Monthly Environmental Monitoring & Audit Report - March 2023

Contract No. CPW 01/2023 Environmental Team for Relocation of Sha Tin Sewage Treatment Works to Caverns

Contract No. CPW 02/2023
Independent Environmental Checker Services for
Relocation of Sha Tin Sewage Treatment Works to Caverns
Verification of Monthly EM&A Report (March 2023)

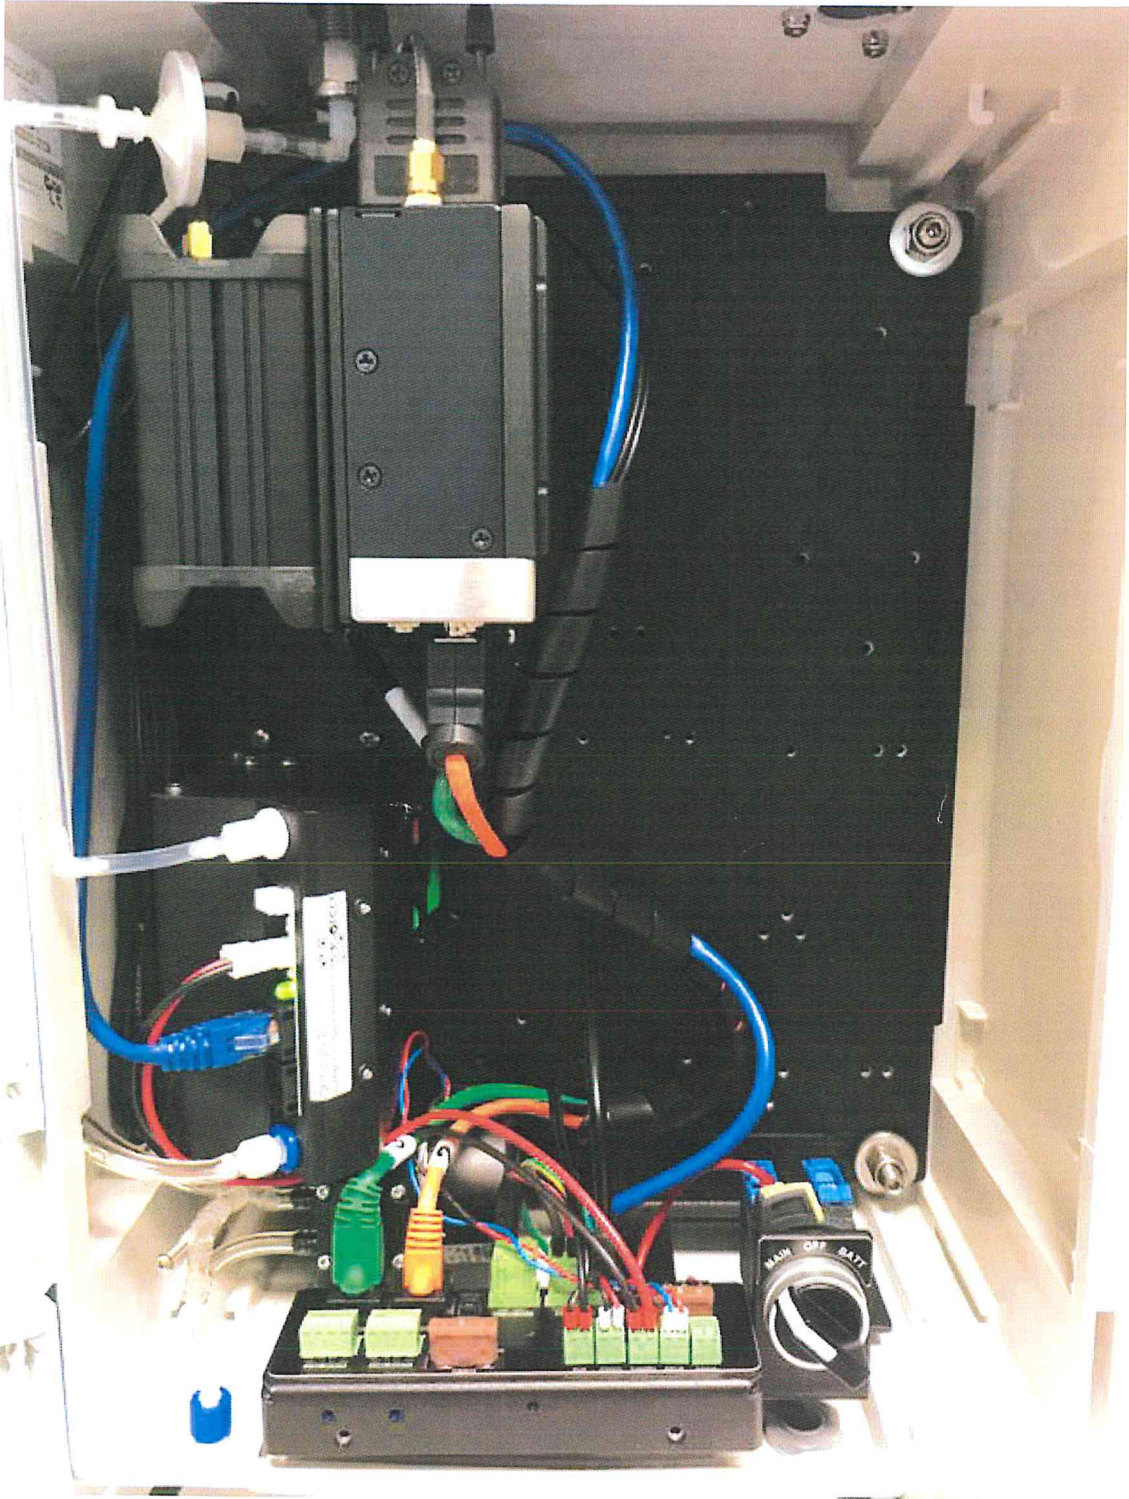
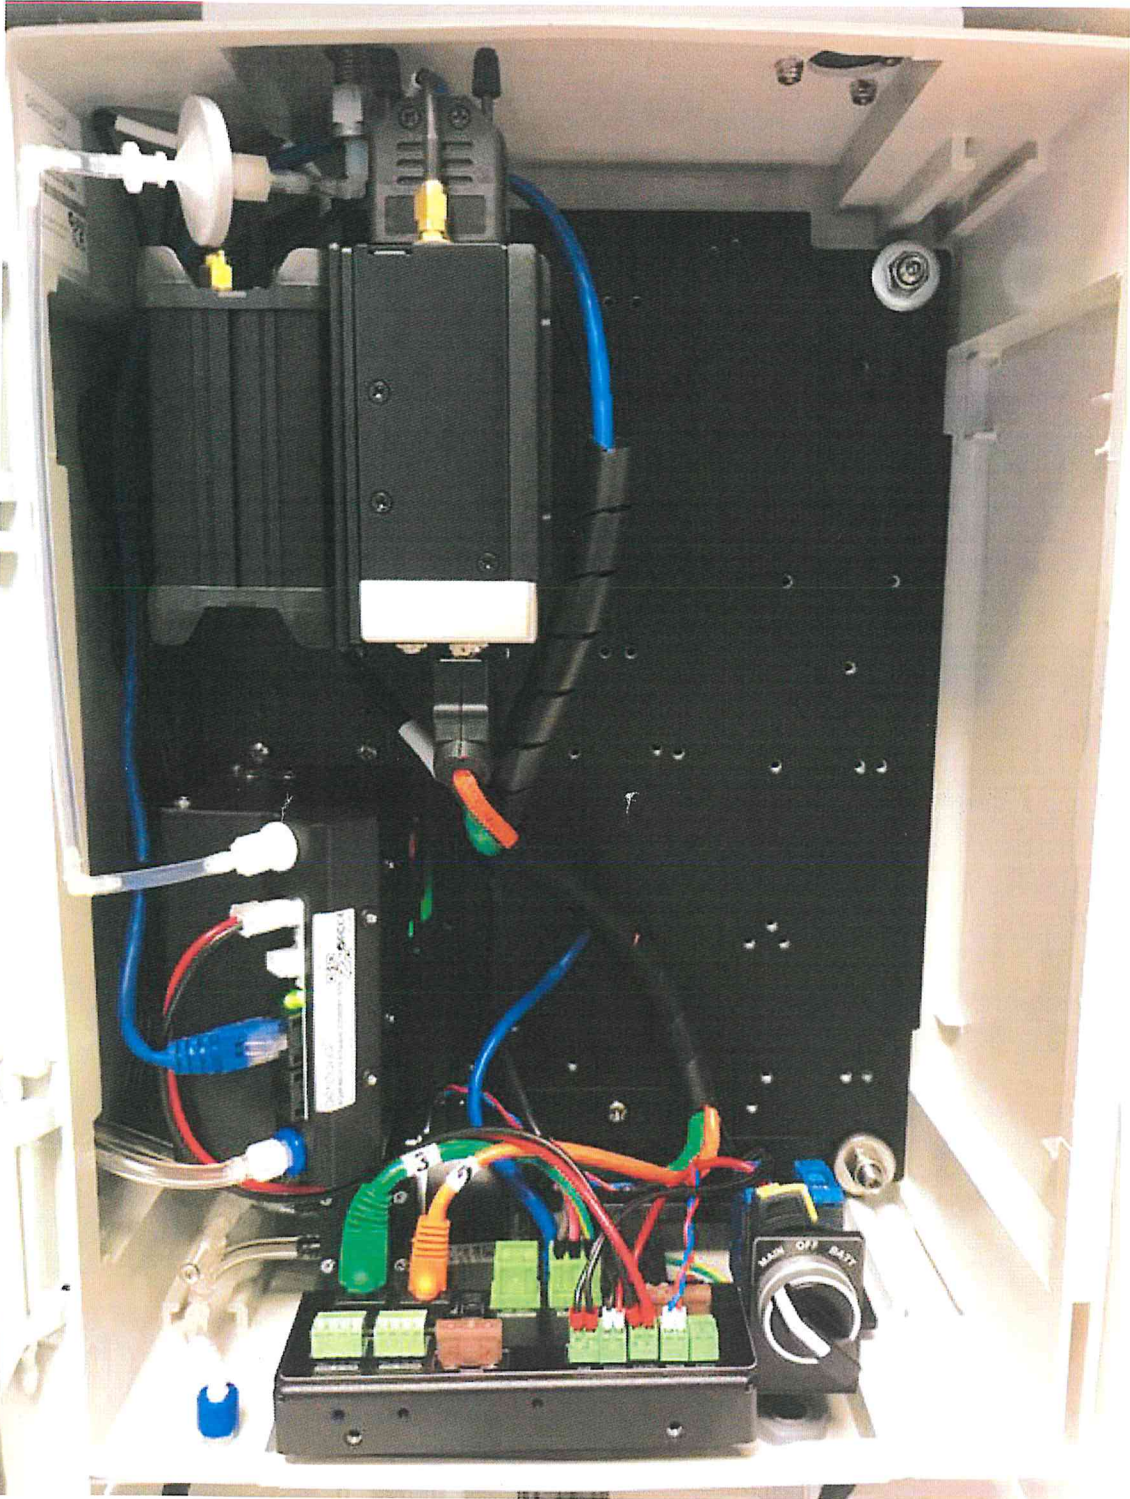
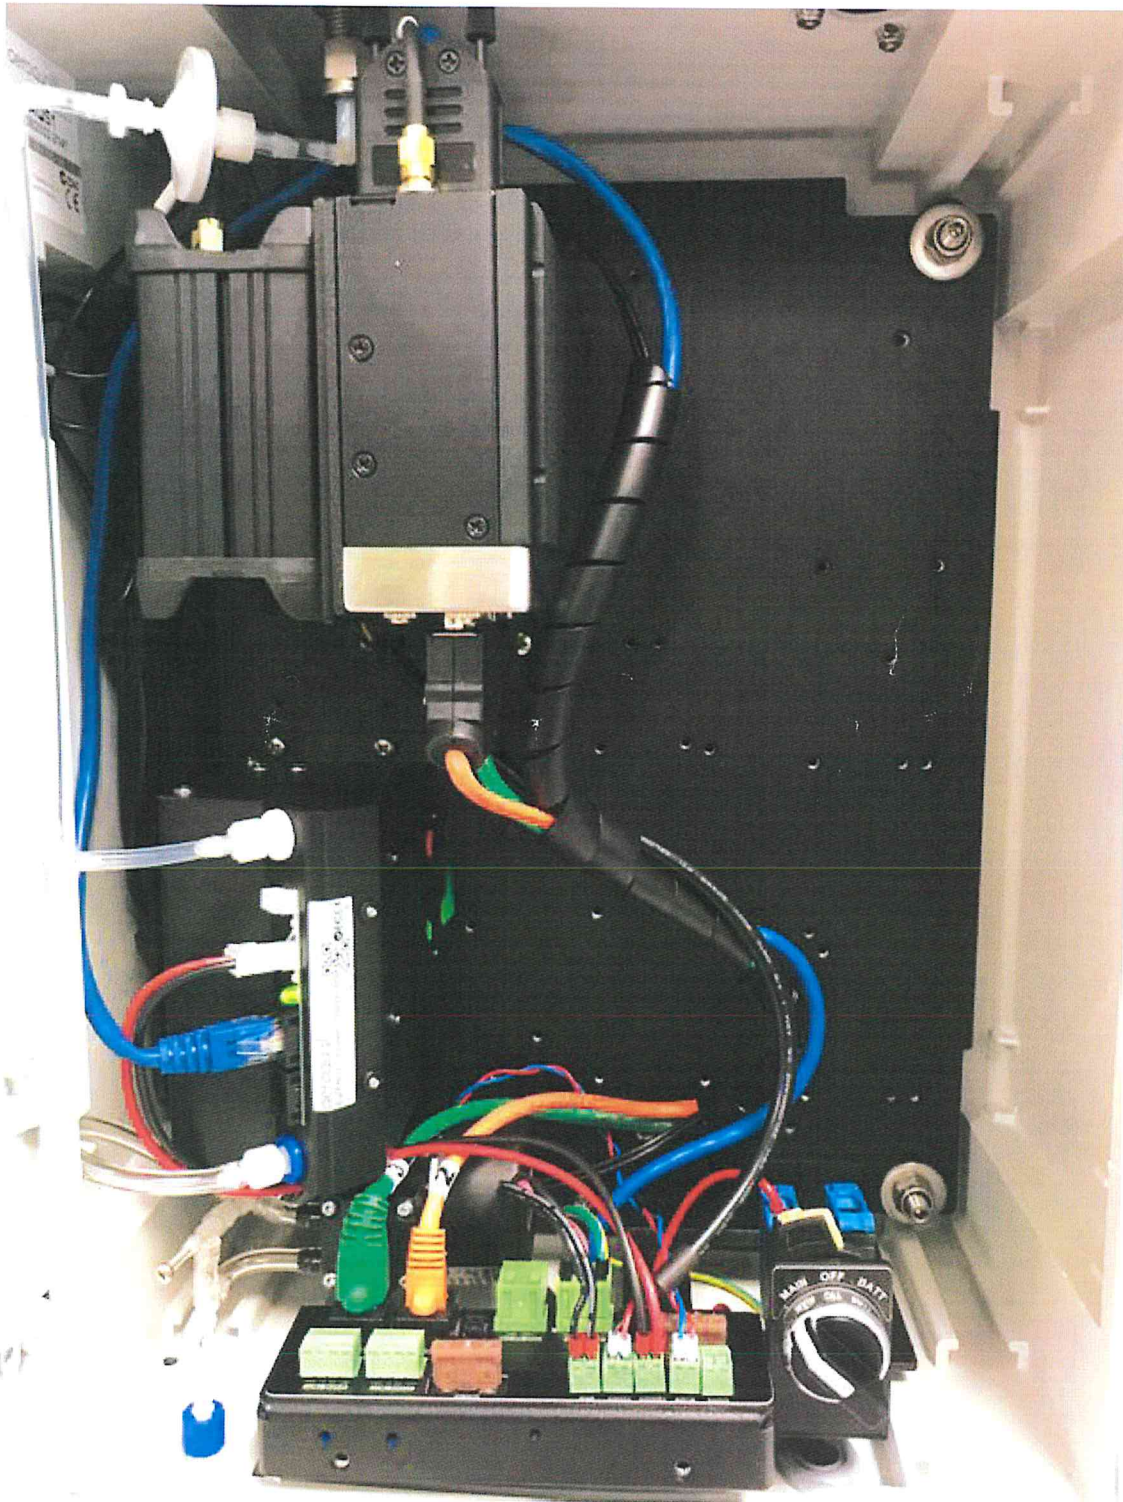
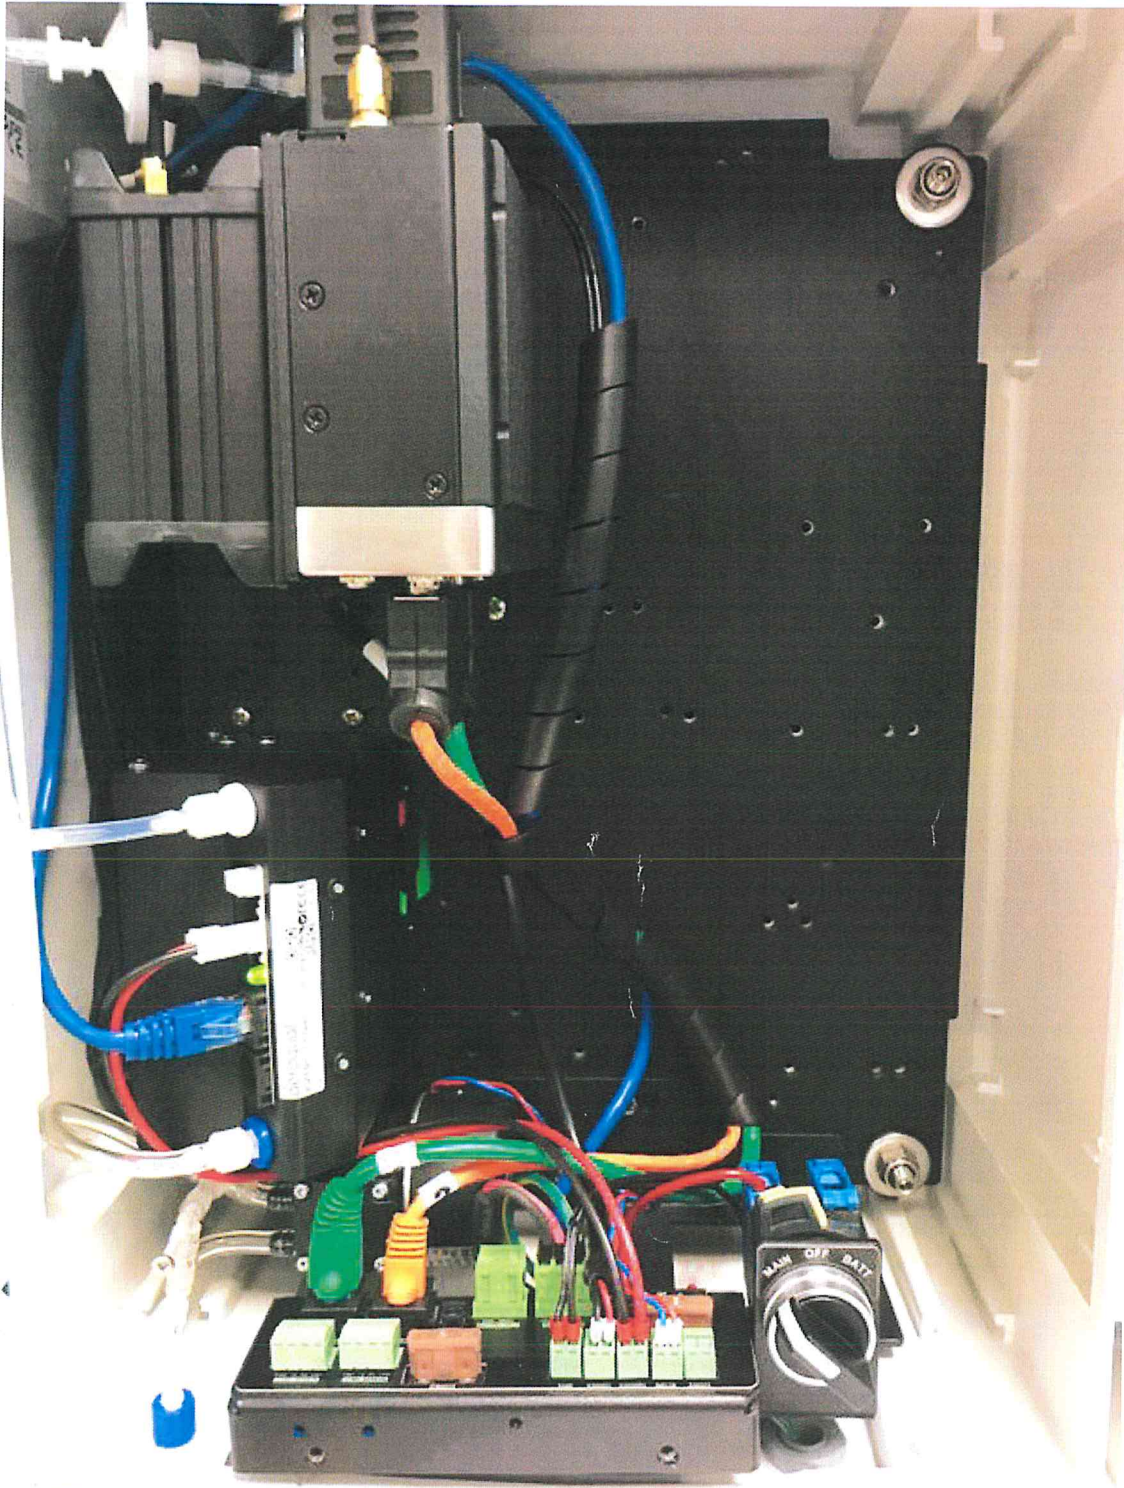
“The dates of calibration for the AQSs with the serial numbers AQS1 17082022-2139, AQS1 17082022-2140, AQS1 17082022-2141 and AQS1 17082022-2142 are not specifically shown on the corresponding calibration certificates attached on page 136 to 147 of the captioned submission. However, it is reasonable to assume that such dates should be close to the dates of approvals (i.e. 17 and 23 August 2022). This verification letter is considered valid by the IEC only when such AQSs were in reality calibrated in August 2022”.
